## Product Change Notification - RMES-02PWOV621

CCB 3832 Final Notice: Qualification of MTAI as a new final test site for selected products of the 0.25 um wafer technology available in 32L PDIP (0.600 in) package.

**CCB 3832\_ Pre and Post Change Summary**  
**PCN#: RMES-02PW0V621**

**QUALIFICATION REPORT SUMMARY**

# Packing Information

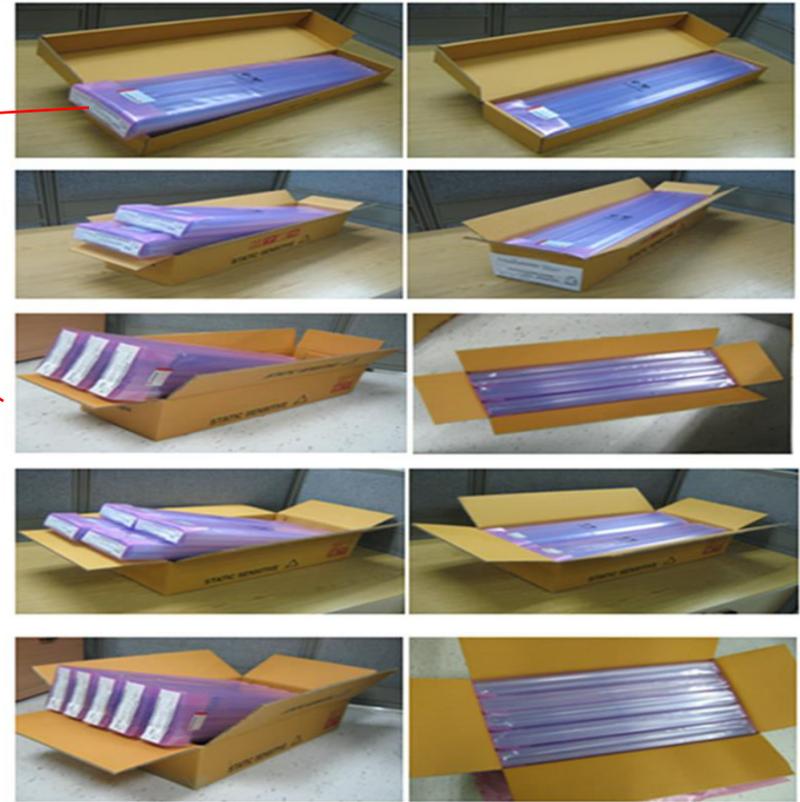
## PRE CHANGE (KYE)

## POST CHANGE (MTAI)

**Pink ESD Bag**

**Inner box**

**Outer carton**

**Inner box only**
